# RETREAT AT TIMBERRIDGE FILING NO. 3

## COUNTY OF EL PASO, STATE OF COLORADO

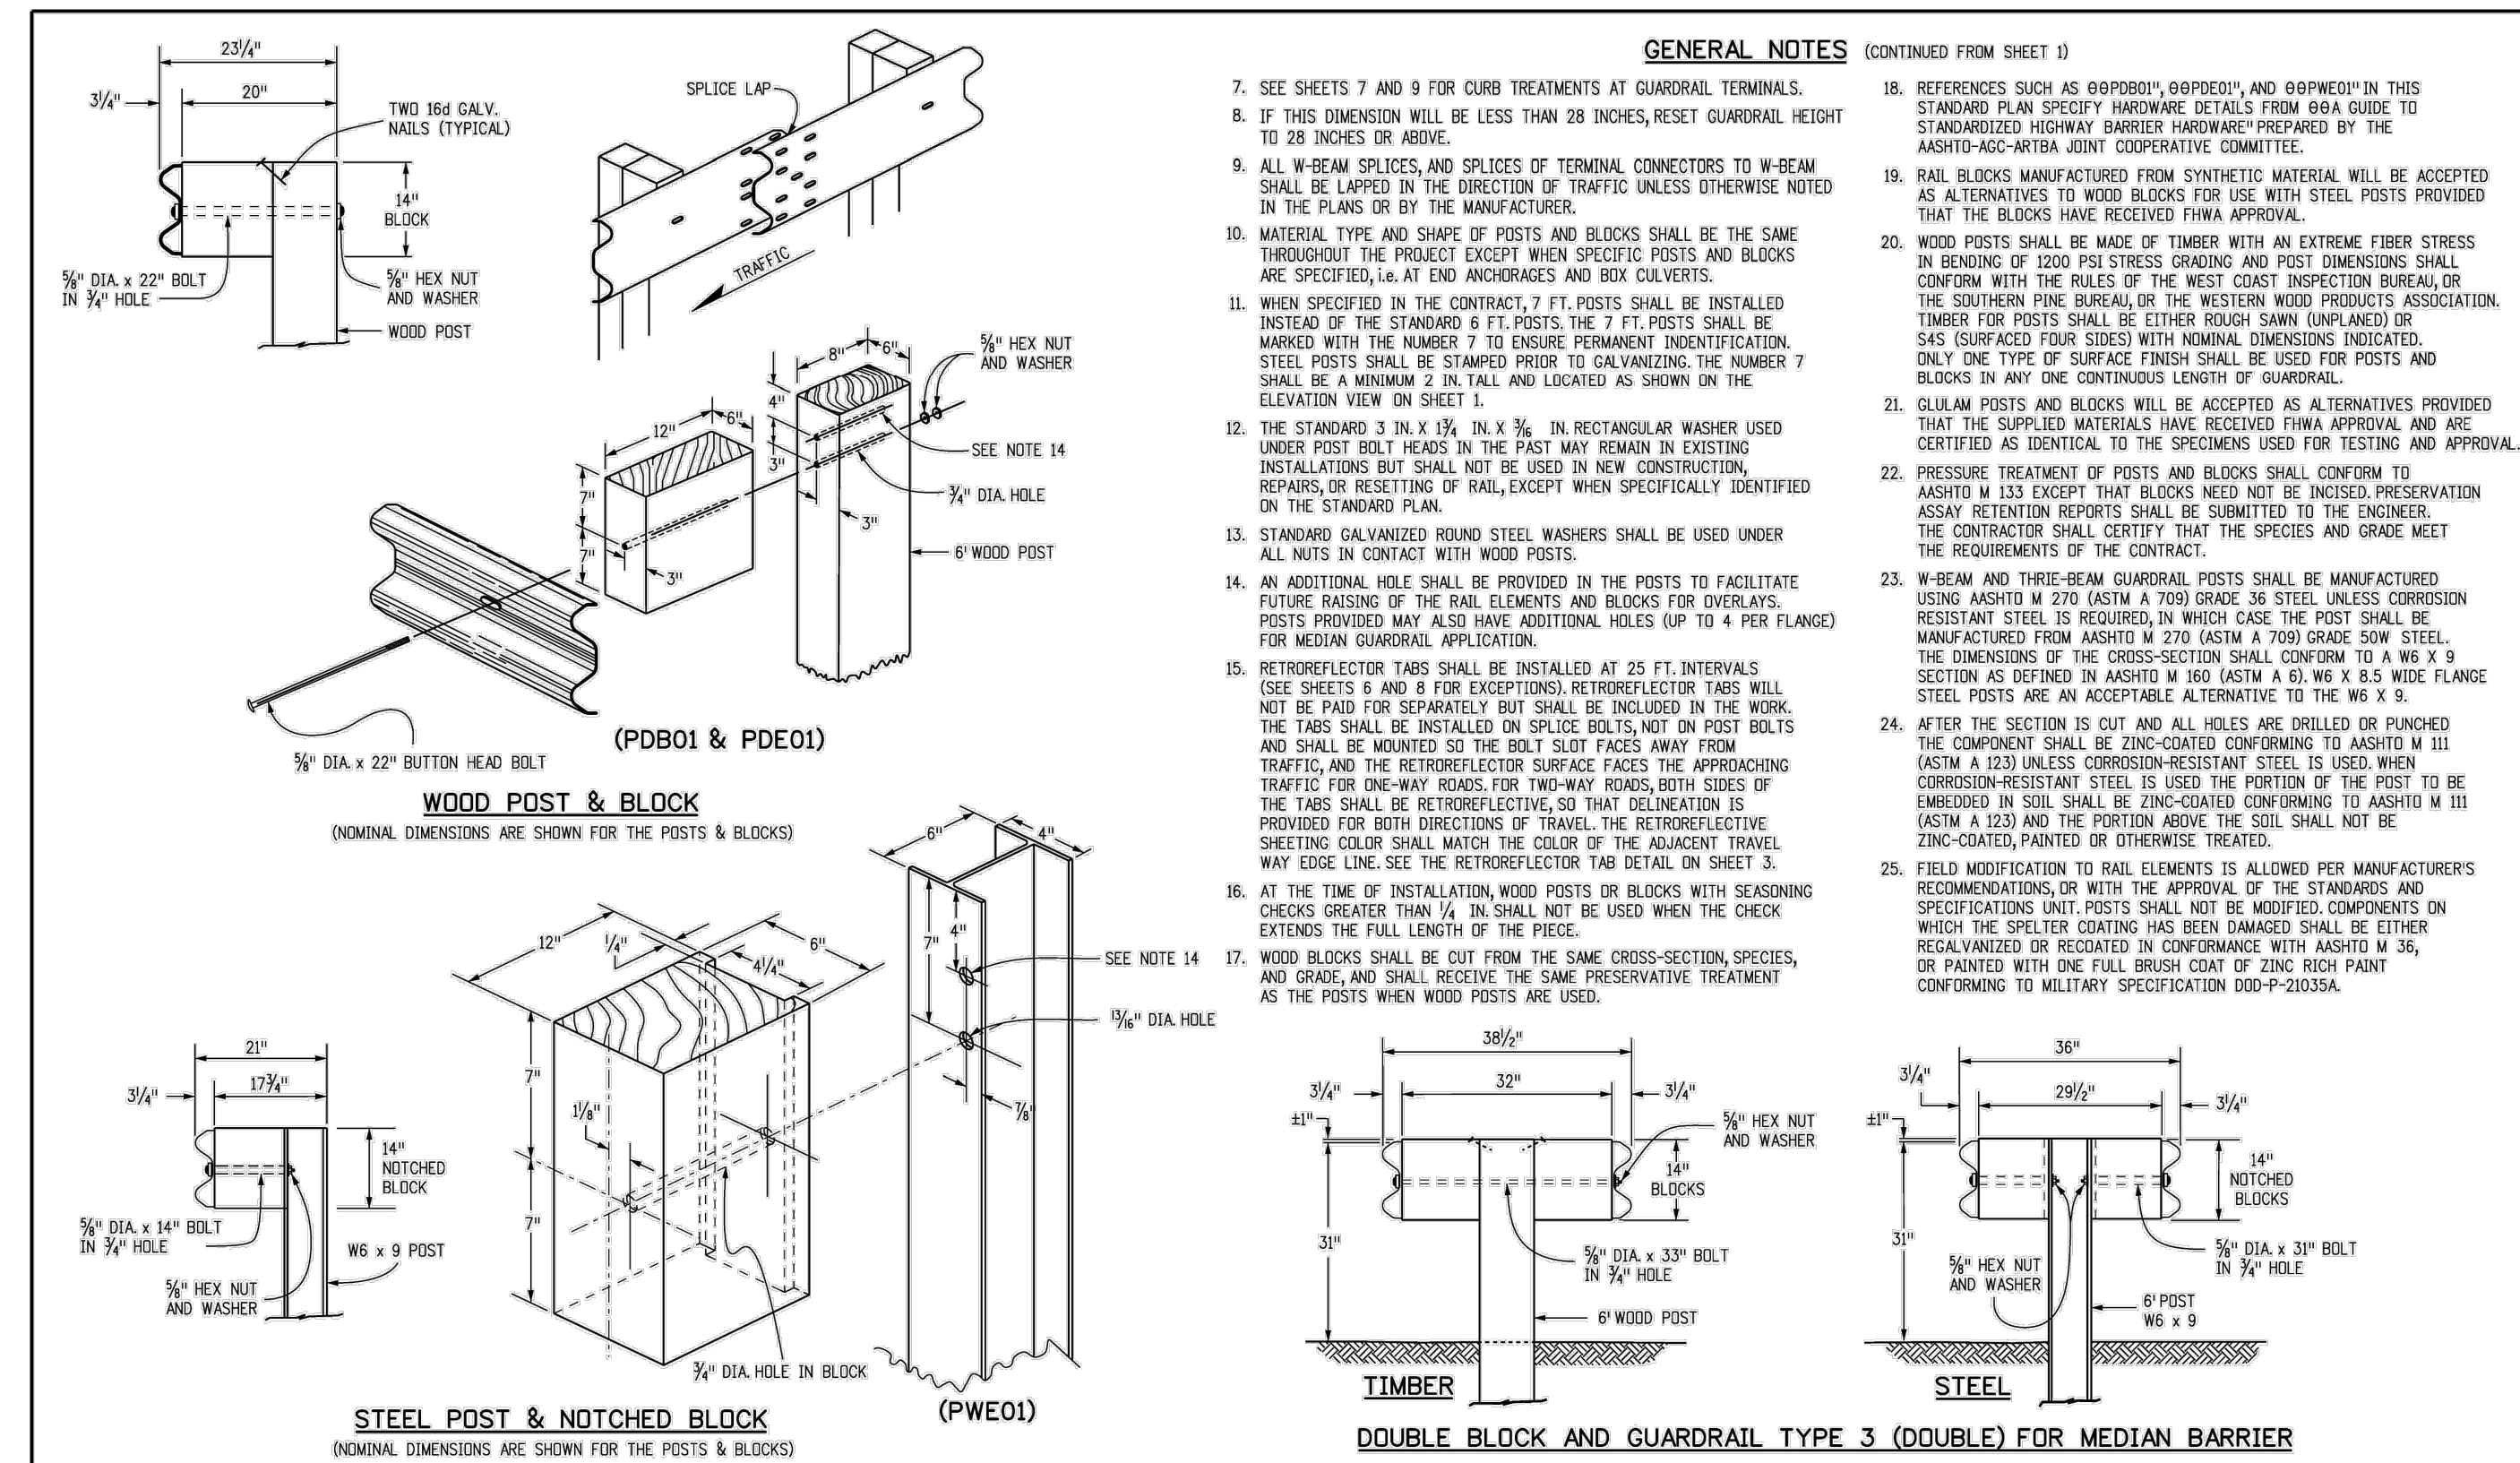
<b>Computer File Information</b>		<b>Sheet Revisions</b>		<b>Colorado Department of Transportation</b>		<b>MIDWEST GUARDRAIL SYSTEM (MGS) TYPE 3 W-BEAM 31 INCHES</b>		<b>STANDARD PLAN NO. M-606-1</b>	
Creation Date: 07/31/19	Designer Initials: JBR	Date: 03/05/20	Comments: Revised per Note 1 to show MASH compliant	2829 West Howard Place	CDOT HQ, 3rd Floor	Denver, CO 80204	Phone: 303-757-9021 FAX: 303-757-9868	Standard Sheet No. 2 of 19	Project Sheet Number:
Last Modification Date: 03/05/20	Detailer Initials: LTA			<b>Project Development Branch</b>		<b>JBK</b>		Issued by the Project Development Branch July 31, 2019	
CAD Ver: MicroStation V8	Scale: Not to Scale	Units: English						Project Sheet Number:

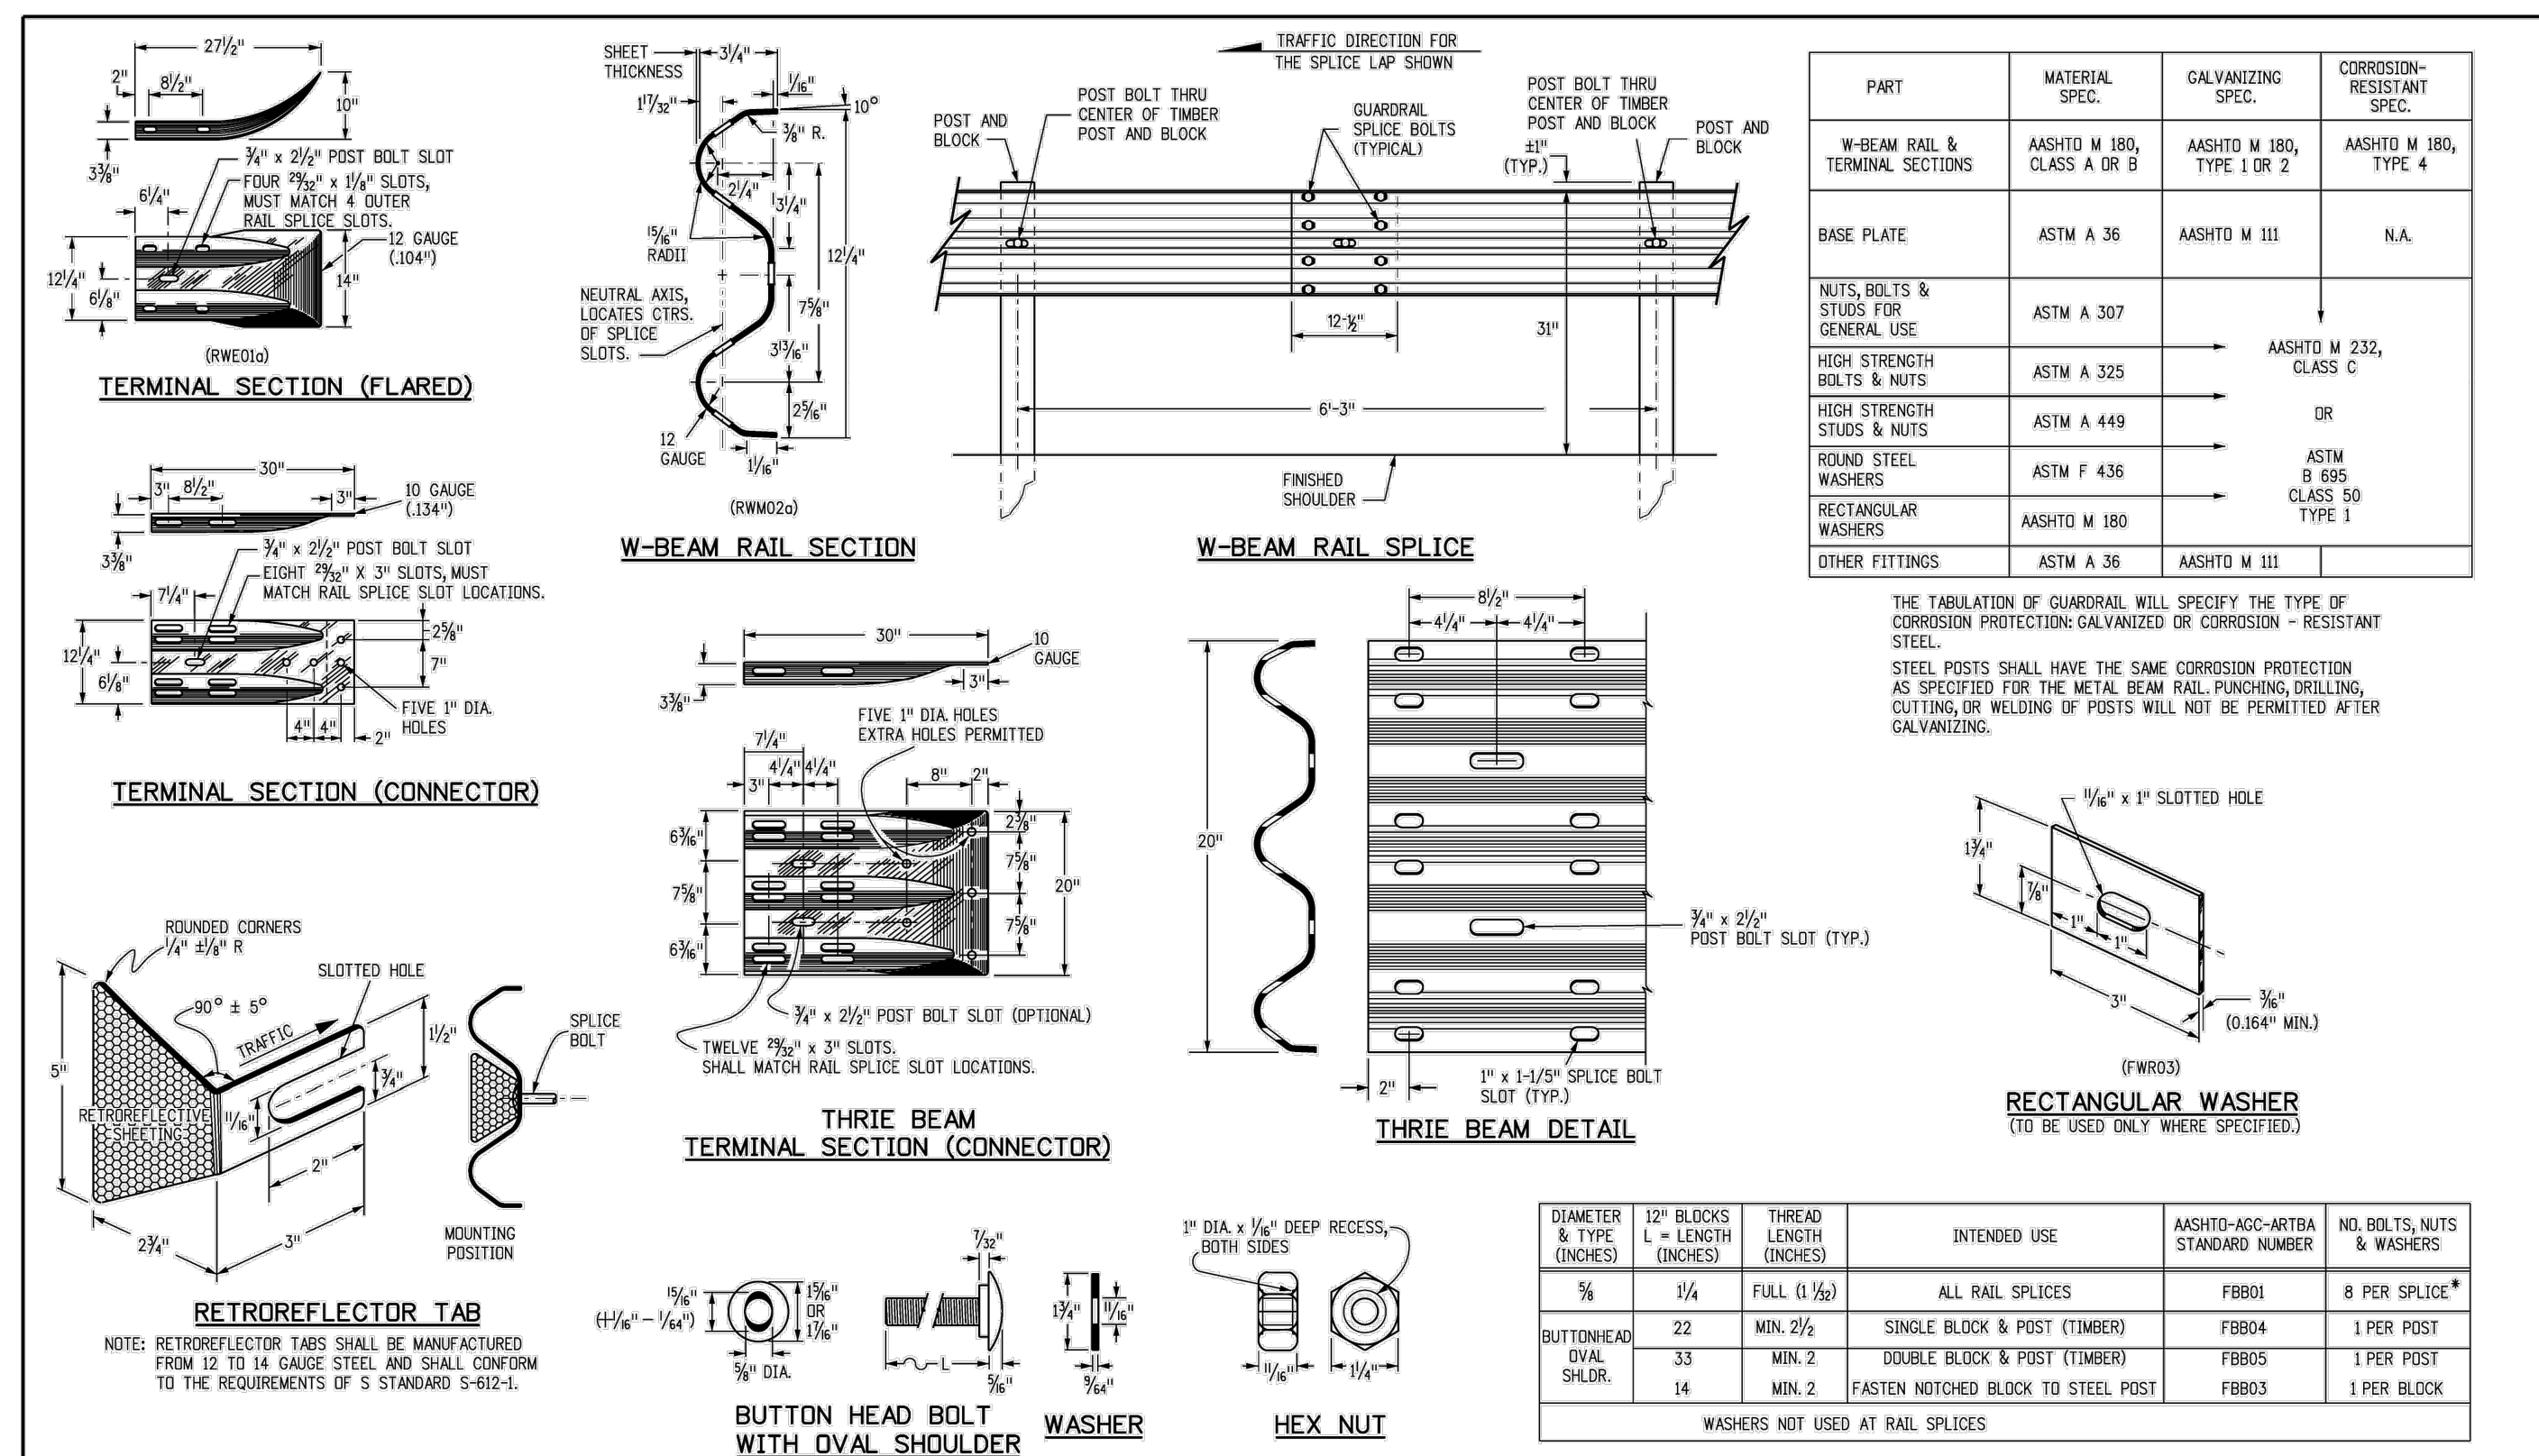
<b>Computer File Information</b>		<b>Sheet Revisions</b>		<b>Colorado Department of Transportation</b>		<b>MIDWEST GUARDRAIL SYSTEM (MGS) TYPE 3 W-BEAM 31 INCHES</b>		<b>STANDARD PLAN NO. M-606-1</b>	
Creation Date: 07/31/19	Designer Initials: JBR	Date: 03/05/20	Comments: Revised per Note 1 to show MASH compliant	2829 West Howard Place	CDOT HQ, 3rd Floor	Denver, CO 80204	Phone: 303-757-9021 FAX: 303-757-9868	Standard Sheet No. 3 of 19	Project Sheet Number:
Last Modification Date: 03/05/20	Detailer Initials: LTA			<b>Project Development Branch</b>		<b>JBK</b>		Issued by the Project Development Branch July 31, 2019	
CAD Ver: MicroStation V8	Scale: Not to Scale	Units: English						Project Sheet Number:
